In the Planning and Environment Court

No 2916/24

AFFIDAVIT

Various comments regarding expanded grounds for appeal. Pages 1-48.

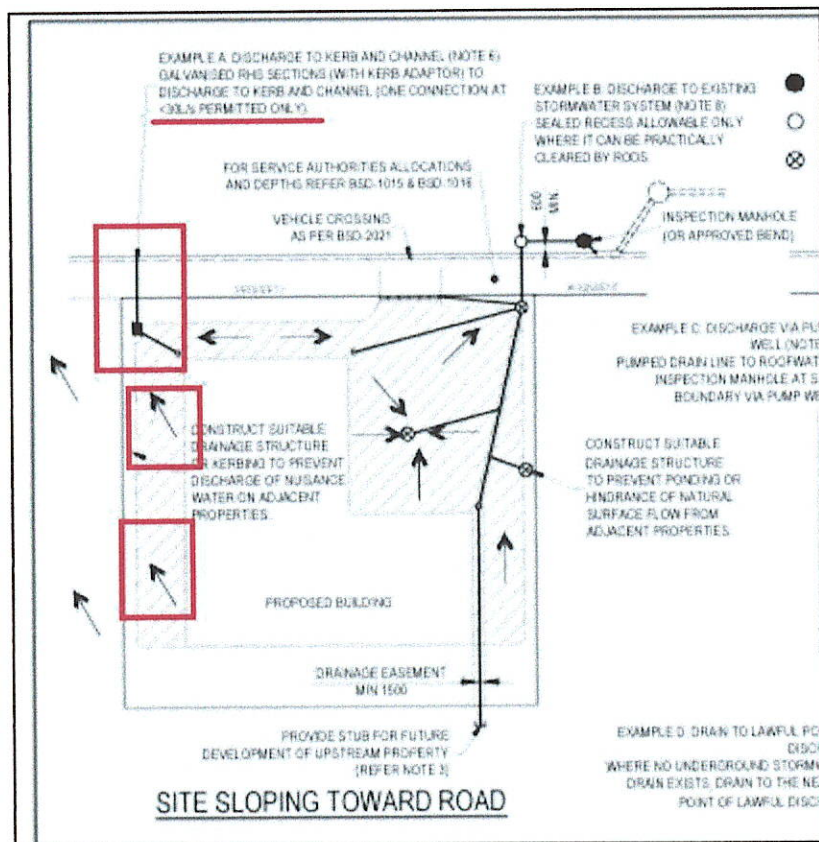
The appellant proposes that the pit for the two Ashridge Rd lots will be where the Council red line upslope pit is shown.

In addition, the pits behind the boundary are totally in the wrong place.

If ever there was proof for incompetence, this is it. A licenced designer would have internal pits close to the boundary. This is aside from the kerb crossing argument. Only a novice pen pusher would place the internal pits 4.9m and 4m from a boundary.

The placing of the internal pit for Lot 1 should be in the driveway. It is not proper to have the internal roof water for the house to suddenly take a dog leg uphill. In addition, this interfere with the fall calculations and makes it more difficult to establish internal drainage fall. Thanks to Council for totally Incompetent internal drainage system that only a non – licenced person would design that way.

Above – BSD 8113 showing rough distance of 500mm from alignment with boundary at kerb for standard crossing.

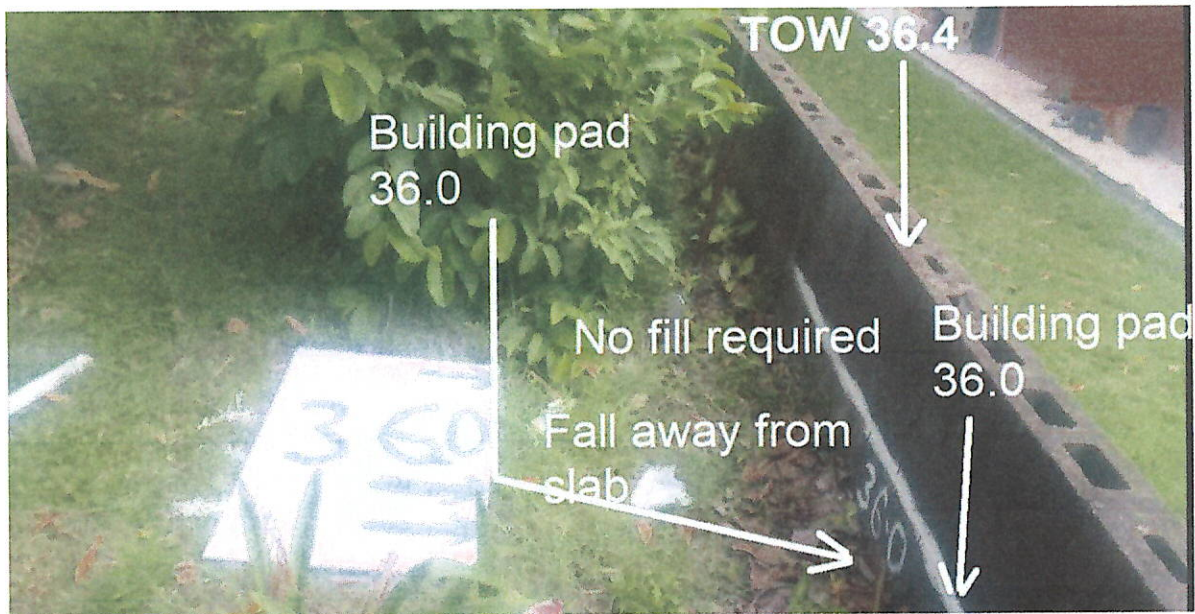
This standard drawing advises that land is to fall away from the house/usable pad. Further rainwater devices such as field gullies are used plus sewerage class SN8 pipes away from the house/usable pad.

Above – demonstration of no need for fill on right side of Usable building pad.

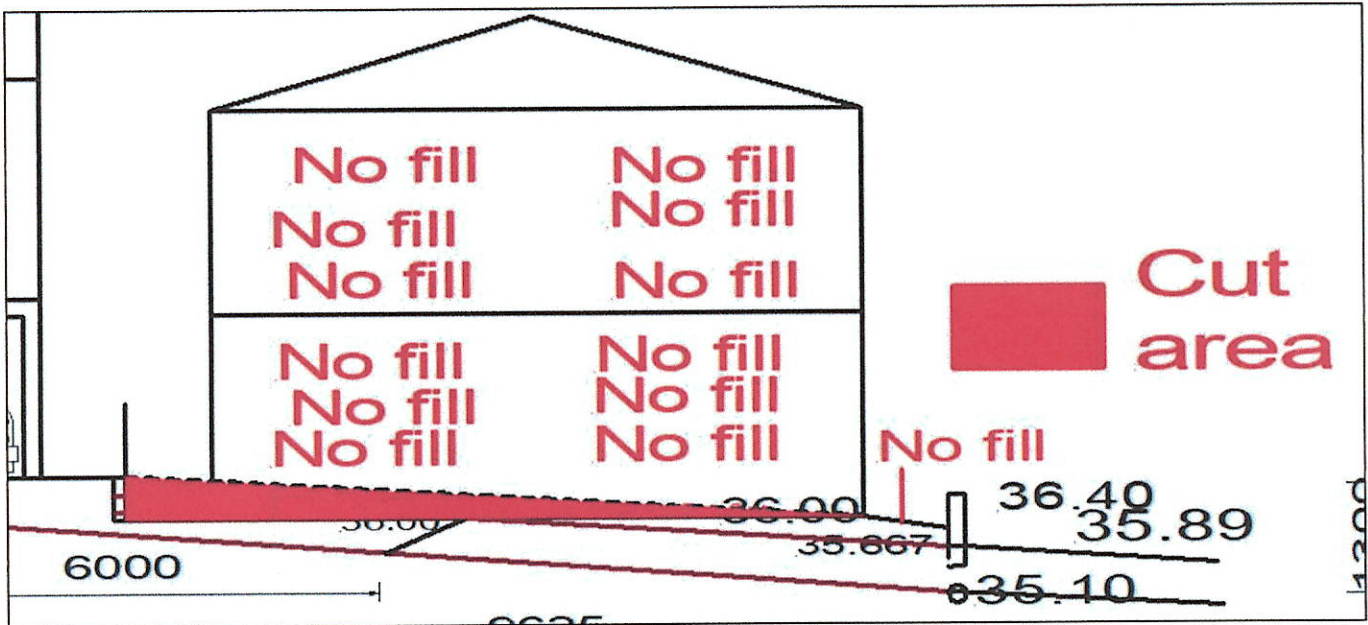
Proposed area of cut by applicant . Note no fill required

Above – appellant’s crosssection Council red line with BSD non-compliant sham triangle

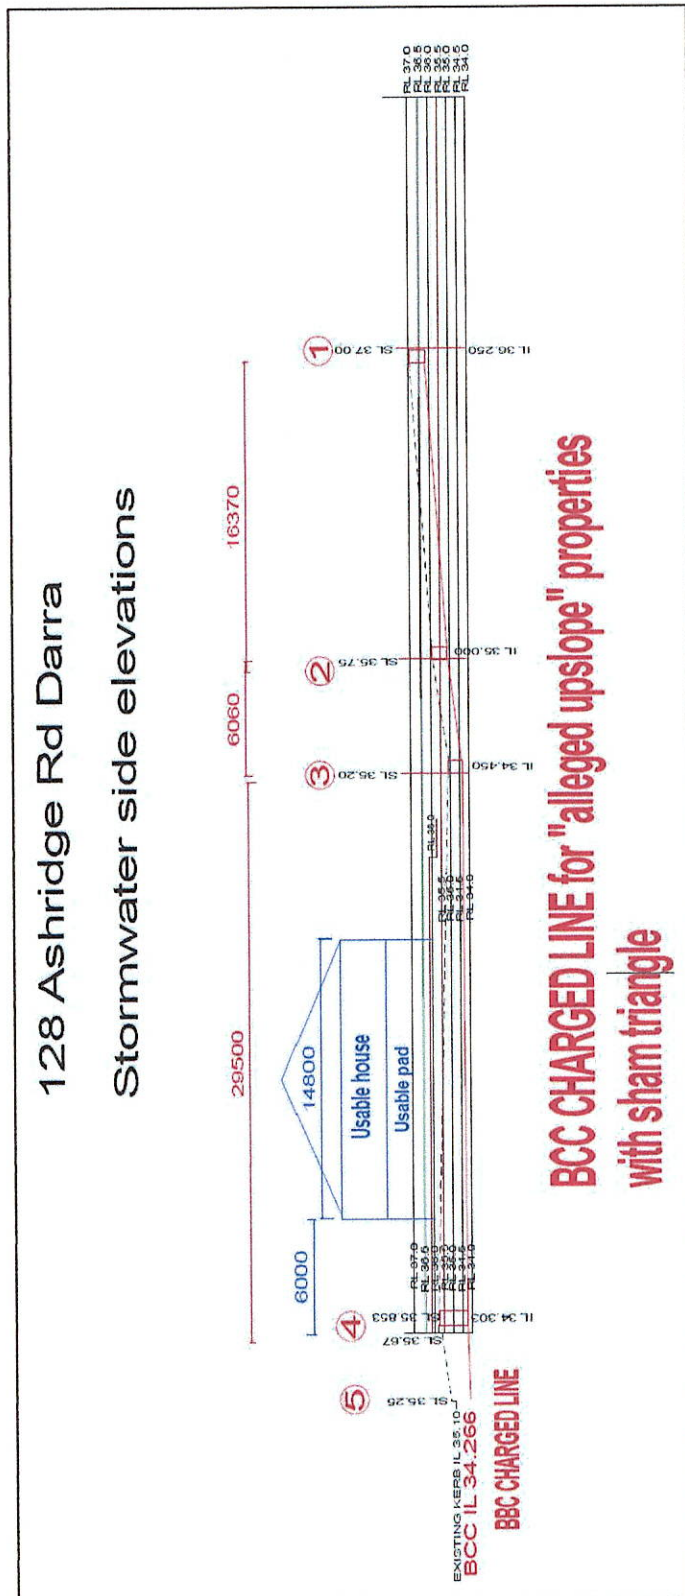
- 1) Cannot be built. Fall calculations. Malfunctioning Council proposed stormwater pipe cannot physically be built by a plumber due to charged fall calculations. Council calculations (whatever they are, oboddy knows) are malfunctioning and also not BSD 8111 compliant.
- 2) Will fill fix the malfunction slope problem ?
- 3) Retaining walls
- 4) Small Lot Code
- 5) There are no Upslop properties
- 6) Conflict of engineering
- 7) Council sham triangle pipe design right rear corner non-compliant with BSD 8111.
- 8) Precedence including 134 Ashridge Rd Darra approval.
- 9) Council refuses to provide City Legal easement document.
- 10) Precedence in separate affidavit by David Manteit of 500 cases approved for Reconfiguration of a Lot 1/1/24 to 121124.

**1) Cannot be built. Stormwater charged pipe calculations malfunction .**

**Action by Council – Changes - S18 to be removed. The red line and pits on approved plan must be removed.**

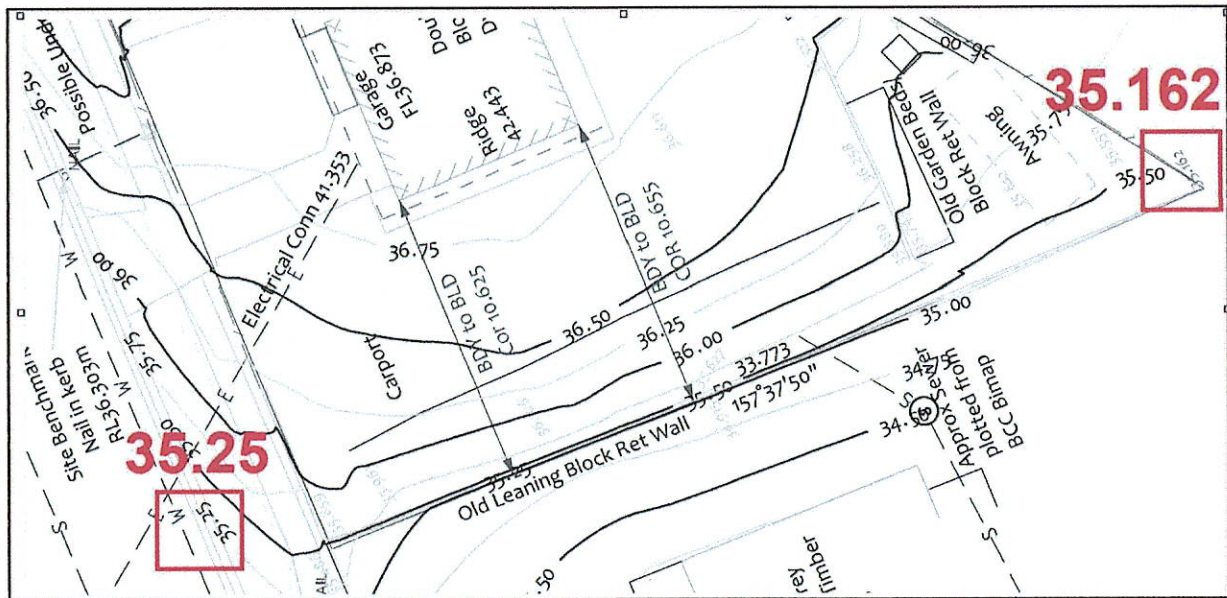
### Fall overall test ?

Lowest surface level point on rear lots at rear boundary to lowest point on subject lot at kerb.

Note – this test does not take into account pipe diameter 300, cover min 450, fall .5% to 1%.

**Conclusion – Fall overall test fails. 128 Ashridge Rd Darra. Therefore rear lots are not upslope lots.**

Definition test fails. Action – Remove S 18 and red line

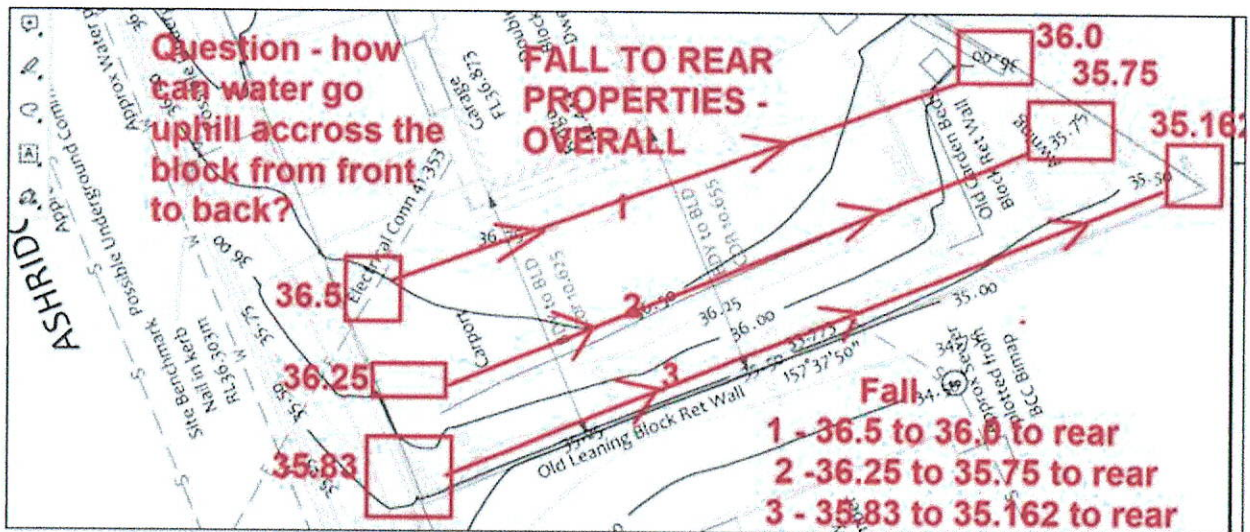
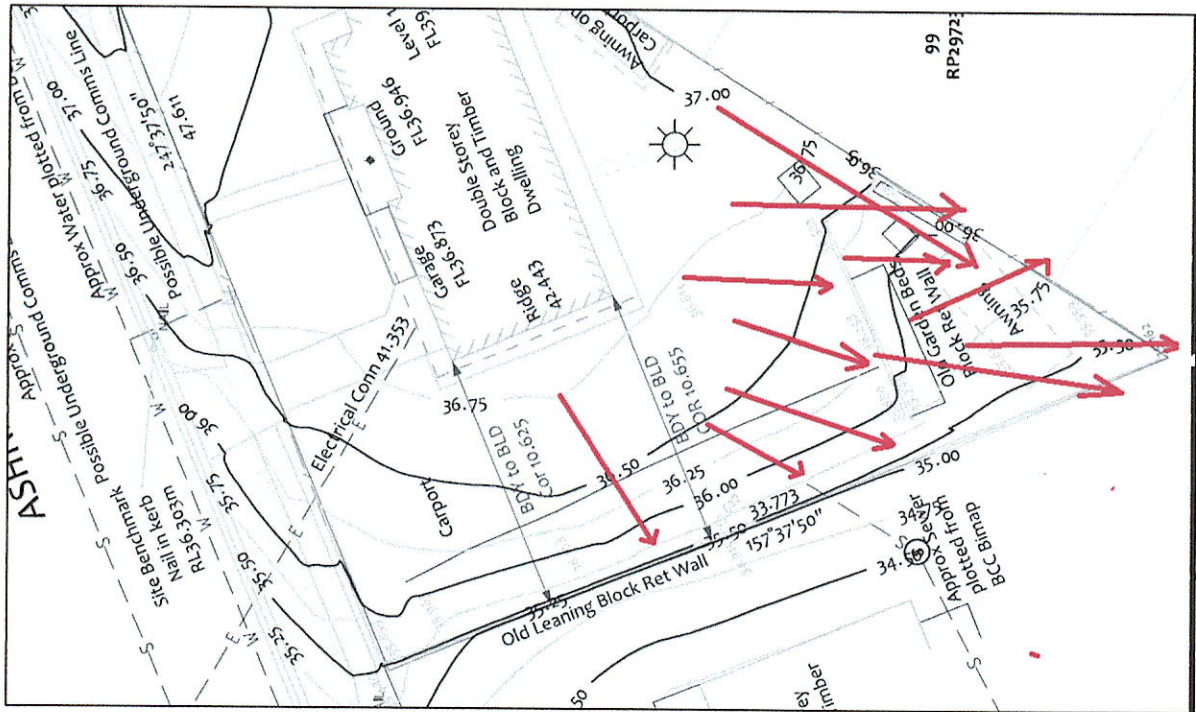
“ That part of the Upslope lots that would flow through the development”

Obviously water wants to fall to the rear lot. It does not want to climb a mountain to flow to Ashridge Rd. Council red line plan cannot force water to travel uphill.

Action – Remove S18 and red line and pits on plan.

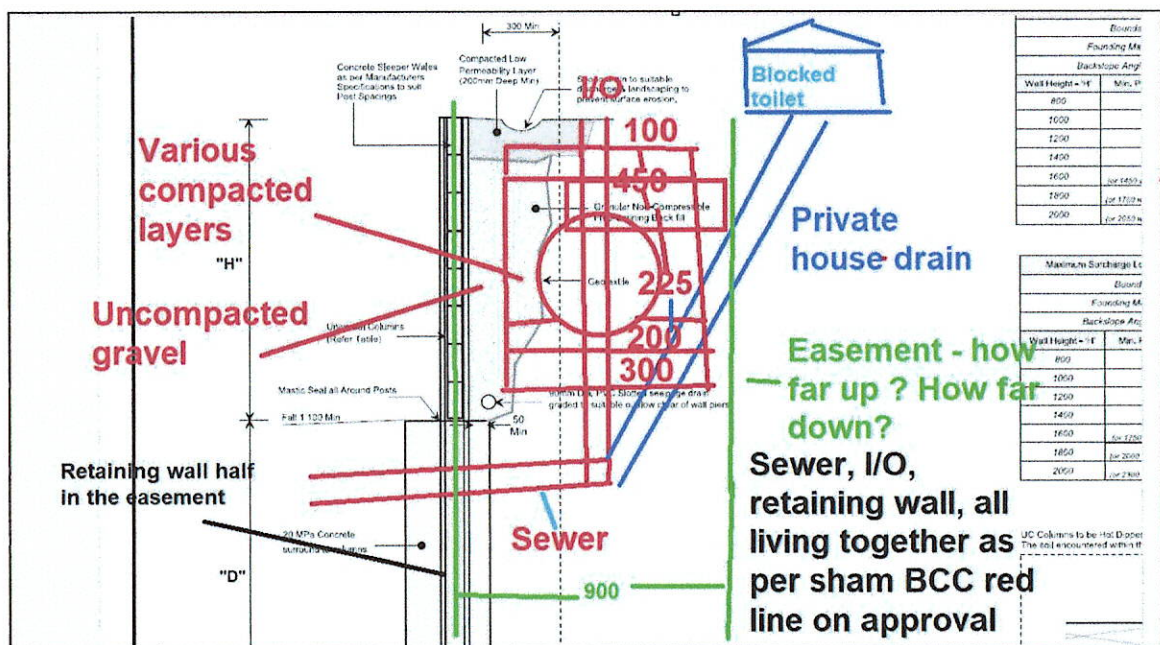
**The stormwater line is in the zone of influence.**

**The Council stormwater plan is dead in the water based on this one argument alone. Simply a bad idea all round.**

**Action – Council to remove S18, stormwater red line.**

## 7) Council triangle question

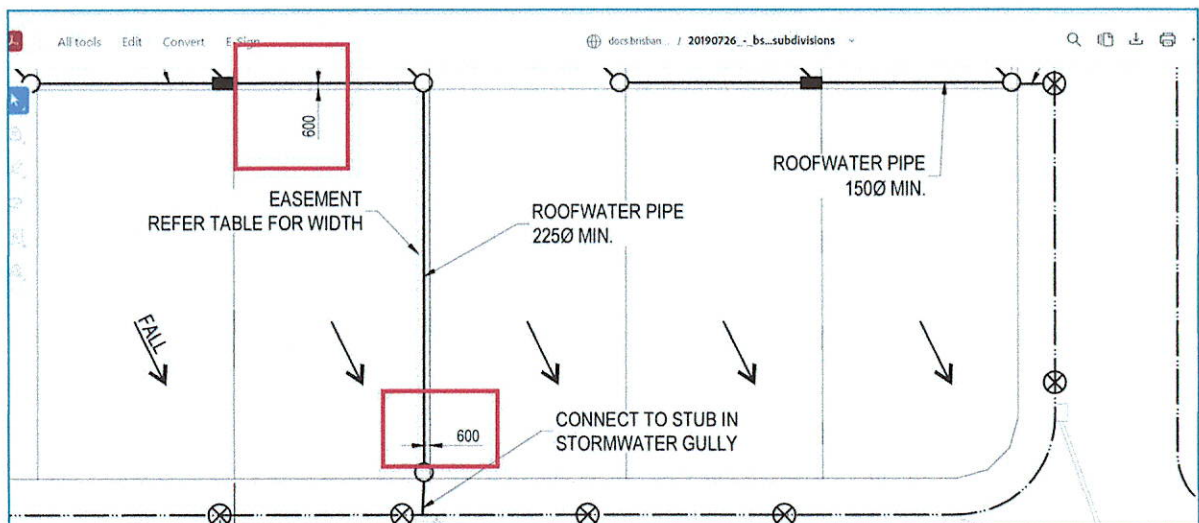
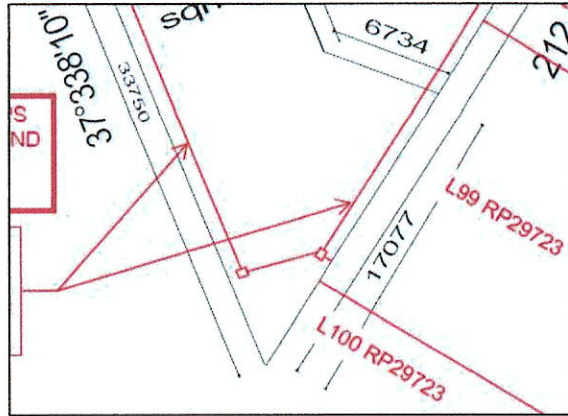
Council have provided no explanation for the triangle. The triangle is BSD 8111 non-compliant.

The only explanation is that they need the triangle to fudge their charged calculations.

BSD 8111 requires that the stormwater pipe be 600mm from the boundary. Why has Council diverted against their own standard diagram ?

Council refuse to advise the applicant why the triangle is in the stormwater pipe design.

Action – S 18 to be removed. Stormwater red line on plan to be removed.
